NO: 2001-02

BULLETIN

SUBJECT: CB700, CB300-SA, & CB300-SATL
Models 3151, 3172, 3172A, 3179, 3179A
Can/Bottle Vendor

SYMPTOM: Double vending of cans.

Figure 4. Wrong
Adjustment needed

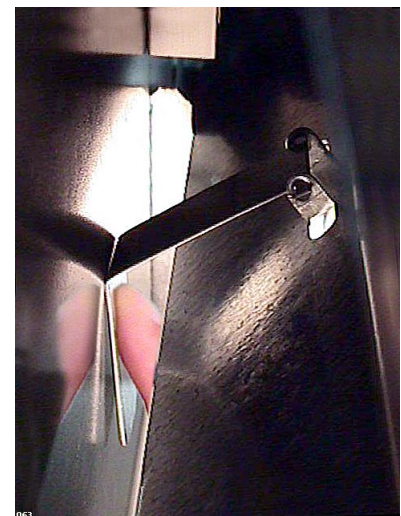
1. Unlock and open the door. Find the **Power Panel** and turn off power.
2. Find the Anti-Tip Finger inside the Stack Assembly. It is located on the bottom near the Product Cradle. See **Figure 1** and **Figure 2**.
3. Check the Anti-Tip Finger to see if it is bent correctly. Use your finger to gently push it against the inner wall. It must swing freely towards the inner wall and the lower half must be flat against the inner wall. See **Figure 3** and **Figure 4**.
4. If it does not fit flat against the inner wall, then it needs to be adjusted.

To bend back, place one finger on the backside of the bend and push against it using the fingers of your other hand. Bend only at the bend-line to keep the bottom half of the part flat.

To bend forward, pull it forward against the stop and push. Bend only at the bend-line to keep the bottom half of the part flat.
